U.S. DEPARTMENT OF THE INTERIOR
Bureau of Land Management
Safford District Office

Final Environmental Impact Statement Sanchez Copper Project

BLM-AZ-PT-93-001-3000

5.5	COMMENT LETTERS AND RESPONSES	5-10

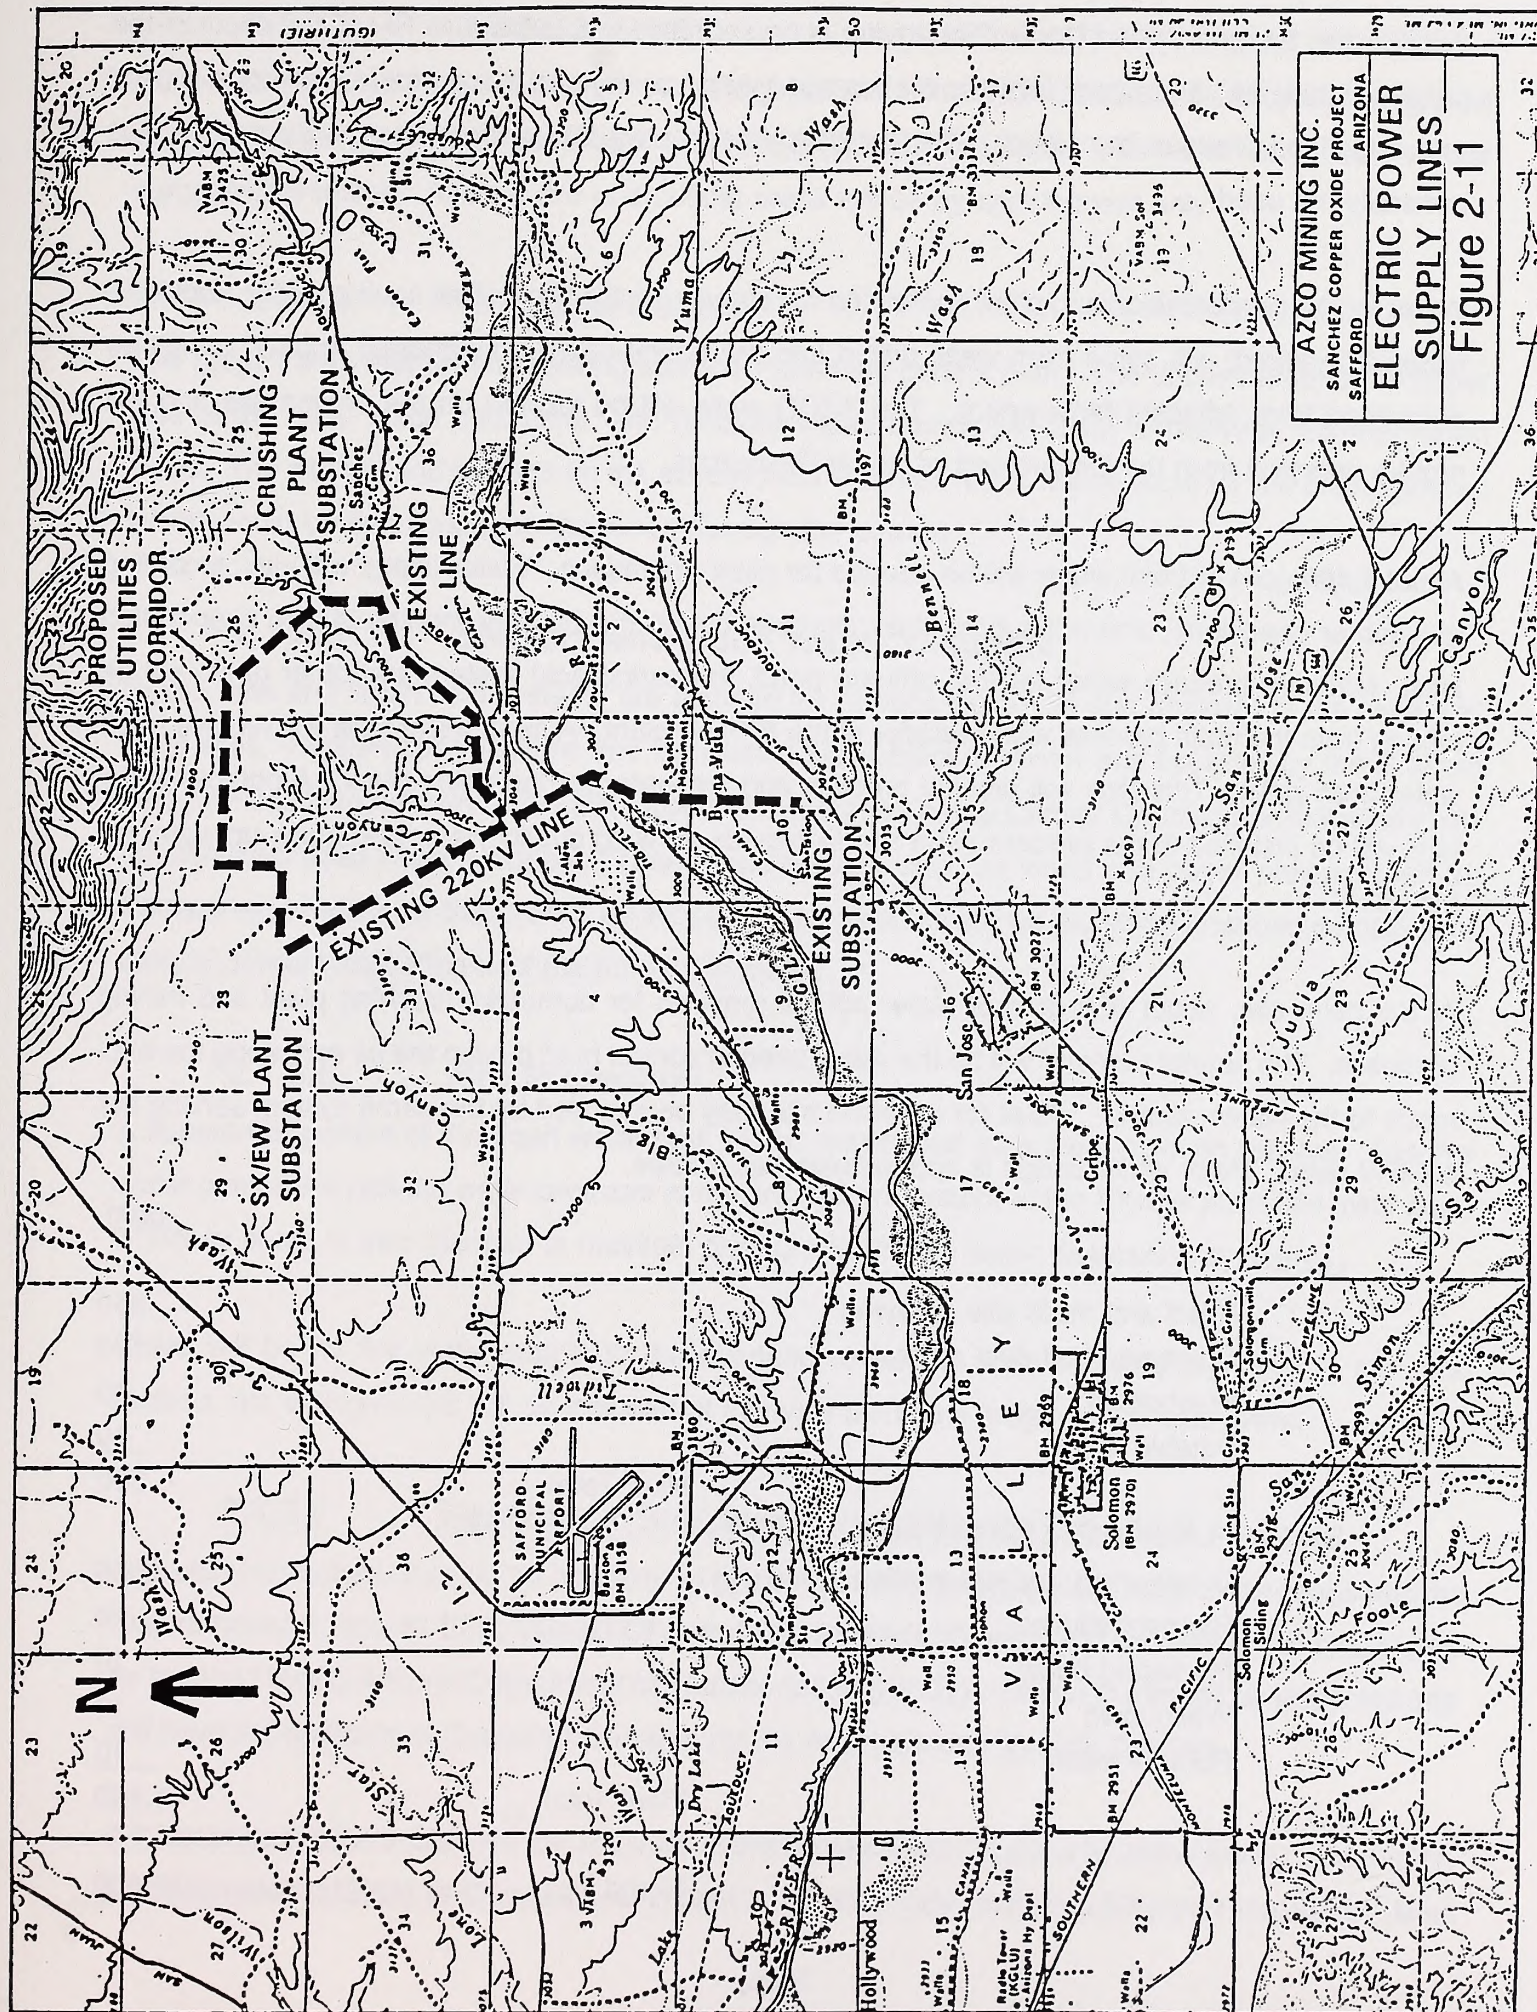
(4) Processing facility designs (see figure 2-11) fail to require groundwater protection, monitoring wells and monitoring plan to followed during and after operations. Similar mitigation measures are also absent for processing chemical and fuel storage

Figure 2-12
Alternative Access

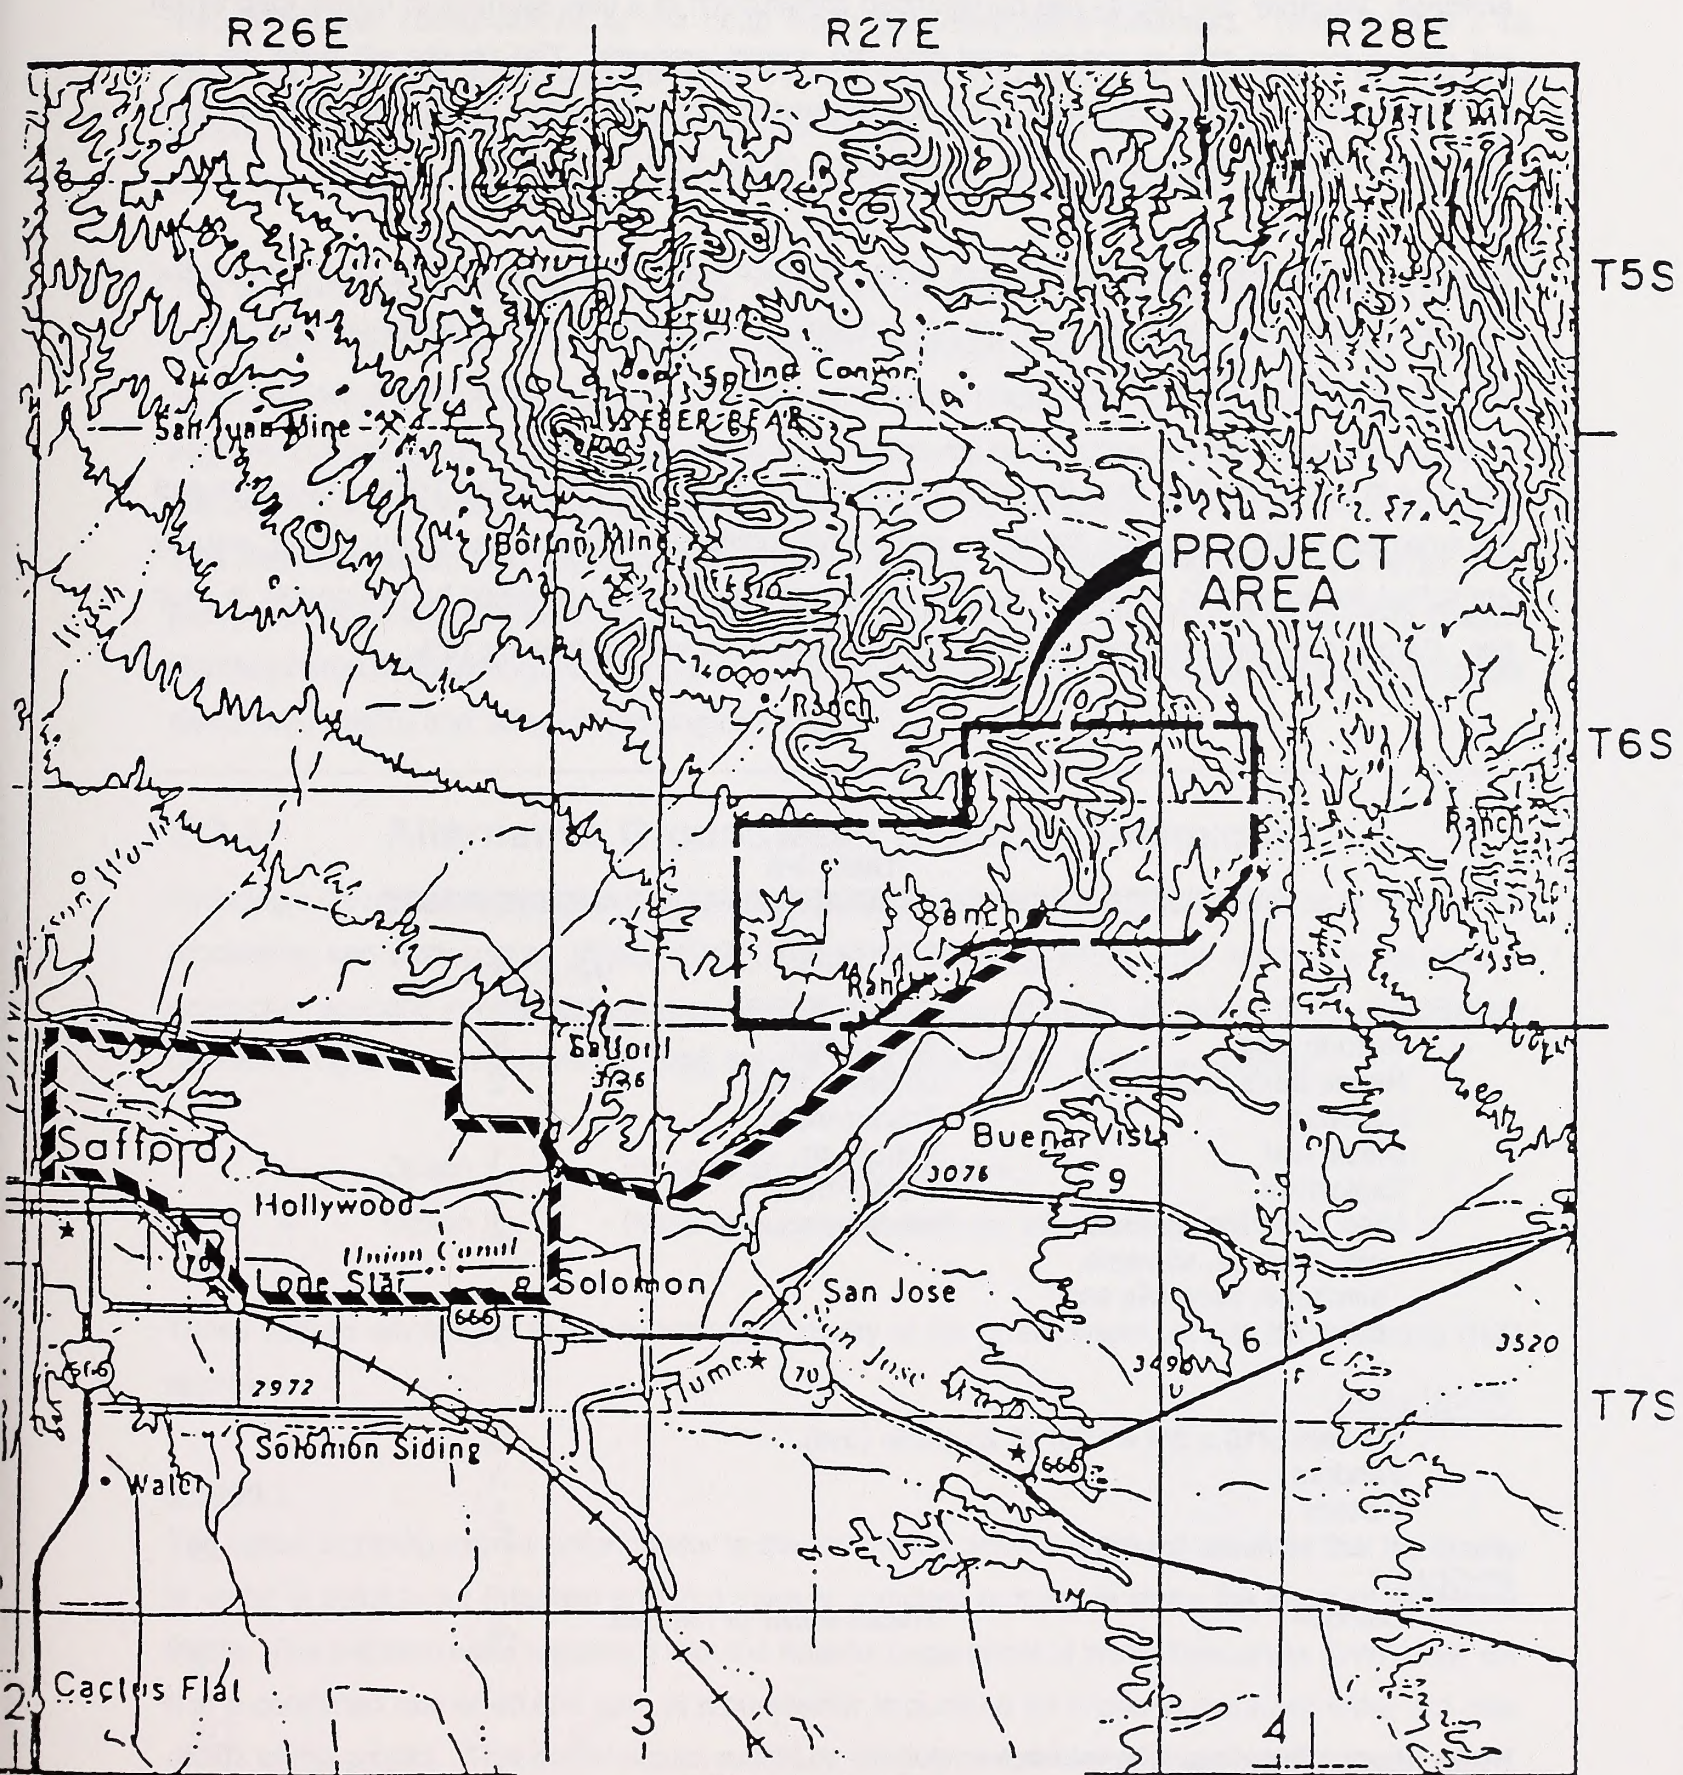
6. Direct impact to our private property: Figure 2-12 indicates a new power line crossing approximately 1/2 to 3/4 of our private land. Nobody has ever talked to us about that. Are we going to be compensated or even have any input as to the location of the power line, or is it just going to be put in? The blasting vibration is supposed to be of no effect, but if it isn't, what recourse do we have? The value of my property is in question, what recourse do I have if the value is lost? Will the county lower my taxes? All of these are questions we have, but the EIS just overlooks impact or potential impact to private land and local residents.

Figure 2-14
Alternative
Heap Leach Pad

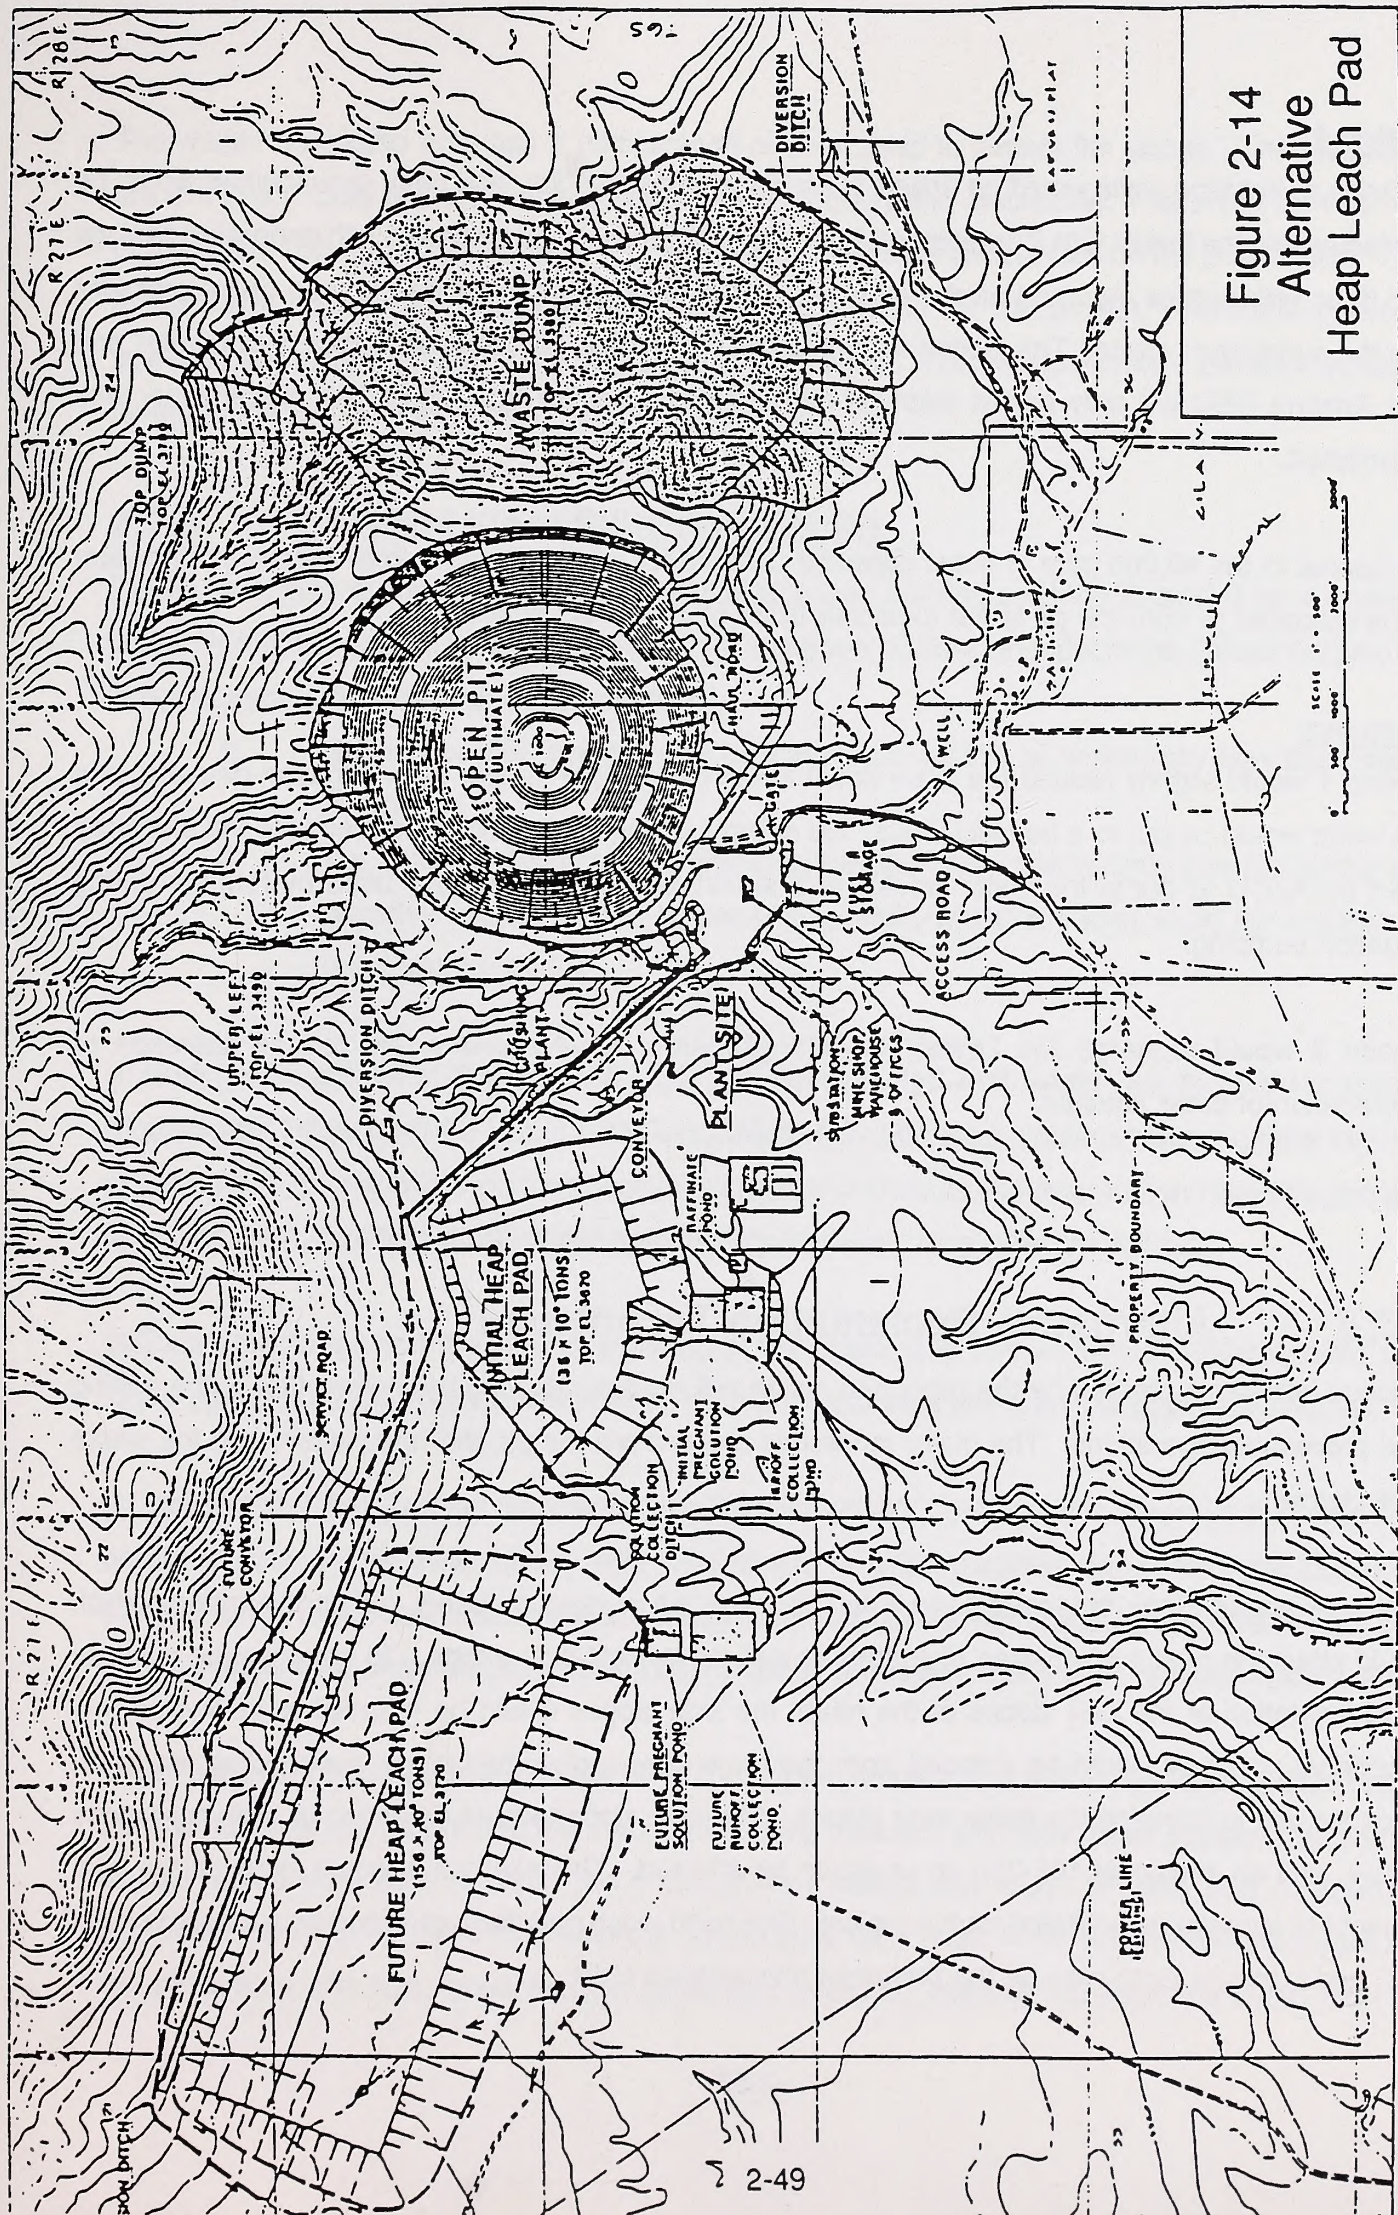
i. One of the alternatives for the leach pad location and plant site, (figure 2-14), would be very well suited to the alternative access and really mitigate impacts to the local residents. It seems to be a good alternate to Azco. Less distance to Safford, closer to power, closer to their wells, don't have to transport material two directions for their process, less drainage problems, etc.
